Project	<b>IEEE 802.16 Broadband Wireless Access Working Group</b> < <a href="http://ieee802.org/16">http://ieee802.org/16</a> >	
Title	<b>Supplement for comments from Yigal Leiba</b>	
Date Submitted	<b>2004-03-13</b>	
Source(s)	Yigal Leiba Runcom Ltd. Hachoma 2 St. 75655 Rishon Lezion, Israel	Voice: +972-3-9528440 Fax: +972-3-9528805 <a href="mailto:yigall@runcom.co.il">yigall@runcom.co.il</a>
Re:	Sponsor ballot on IEEE P802.16-REVd/D3-2004	
Abstract	Supplementary text and drawings to comments submitted to sponsor ballot	
Purpose	Adopt text into the standard	
Notice	This document has been prepared to assist IEEE 802.16. It is offered as a basis for discussion and is not binding on the contributing individual(s) or organization(s). The material in this document is subject to change in form and content after further study. The contributor(s) reserve(s) the right to add, amend or withdraw material contained herein.

**Figure aaa—Example of allocation for AAS\_DL\_Scan IE**

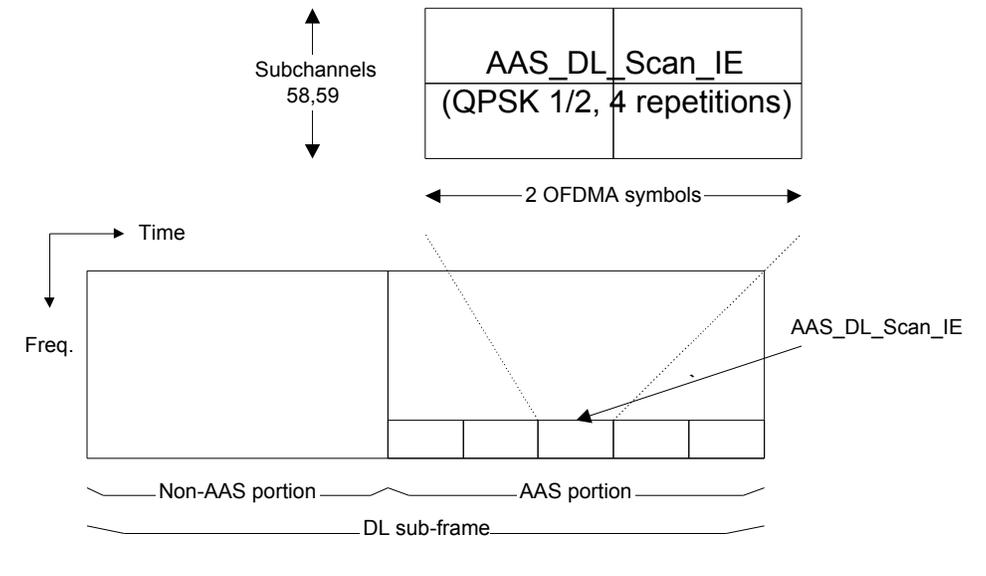
*Update the text in page 464, line 1 (8.4.4.7) with the following,*

Sub-channels 3058 and 3159 of the DL frame may be dedicated at the discretion of the BS for active AAS scanning. When these subchannels are used for this purpose, they shall not be allocated in the normal DL-MAP message and shall be used only on the AAS portion of the DL sub-frame. These sub-channels will be used to transmit the AAS\_DL\_Scan\_IE(), whose physical construction is shown in Figure aaa. The AAS\_DL\_Scan\_IE() is transmitted with a well known modulation and coding, namely QPSK rate 1/2 with 4 repetitions.

**Figure ddd—Mapping order of ARQ-ACK FAST FEEDBACK messages to the ARQ-ACK FAST FEEDBACK region**

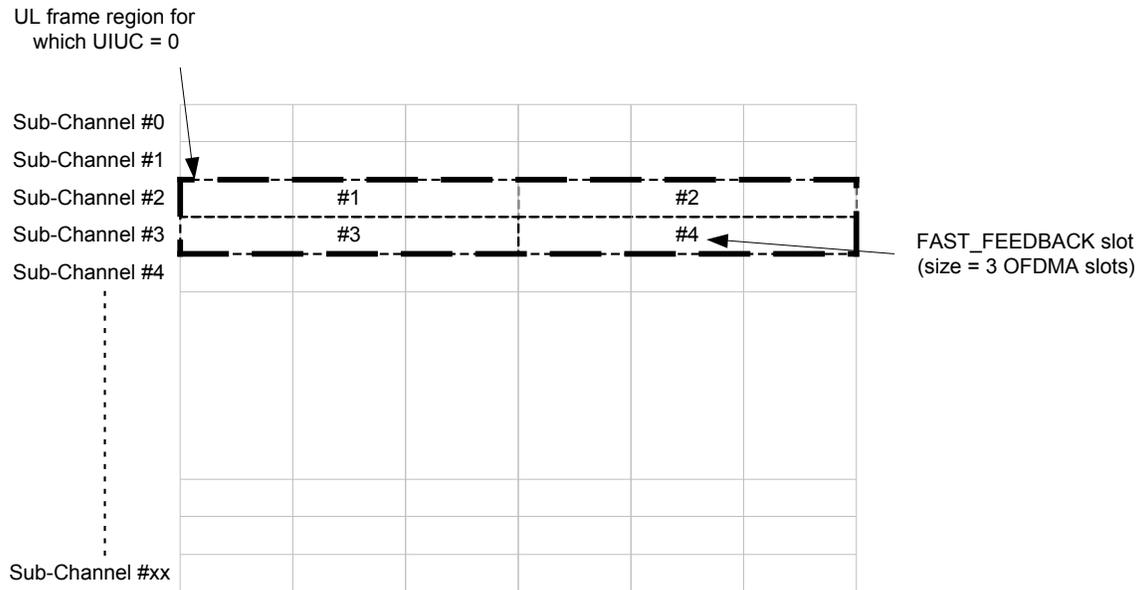
*Update the text in page 475, line 12, (8.4.5.4.5) with the following,*

Each ARQ-ACK FAST FEEDBACK message occupies one ARQ-ACK FAST FEEDBACK Slot which consists the UL preamble and the ARQ-ACK FAST FEEDBACK message payload. ARQ-ACK FAST FEEDBACK messages are mapped in to the region marked by UIUC=0 in the UL-MAP, in a time-first order, as shown in Figure ddd.

**Figure ggg—Mapping of MIMO coefficients to fast MIMO feedback payload bits**

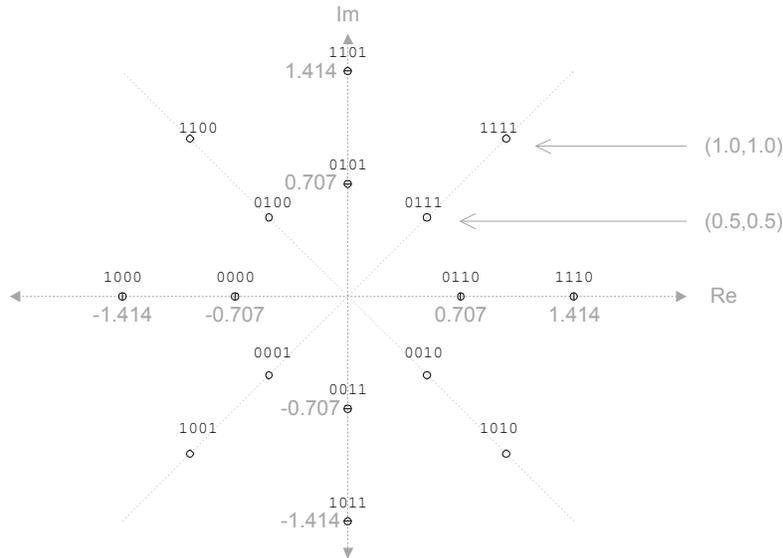
When the FAST\_FEEDBACK subheader *Feedback Type* field is ‘01’ or ‘10’ the SS shall report the MIMO coefficient the BS should use for best DL reception (see section 8.4.8.8). The following mapping shall be used for the complex weights,
